ADA Curb Ramp New Construction Inspection Form (Parallel)

Nw 314th ave

24952.54

Nw. Kaybern st.

PARALLEL RAMP (PL)

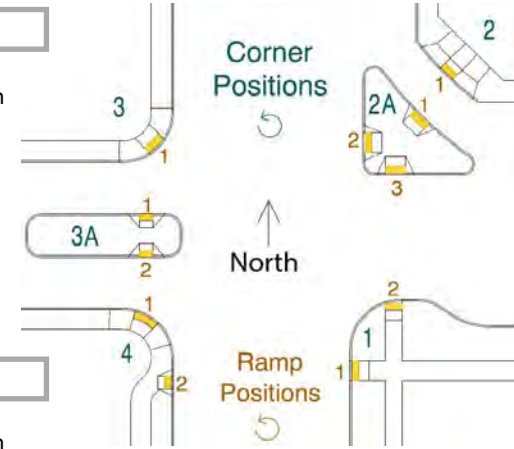
4.8 $\leq 2.0\%$ ☐ $> 2.0\%$ ☒

2.4 $\leq 2.0\%$ ☐ $> 2.0\%$ ☒

N Y ☐ N ☒

4.7 $\leq *$ ☐ $> *$ ☒

4.3 $\leq |5.0\%|$ ☐ $> |5.0\%|$ ☒

13.5 $\leq 8.3\%$ ☐ $> 8.3\%$ ☒

4.15 $\geq 4.0'$ ☐ $< 4.0'$ ☒

4.95 $\geq 4.0'^{*1}$ ☐ $< 4.0'^{*1}$ ☒

No detectable warning,
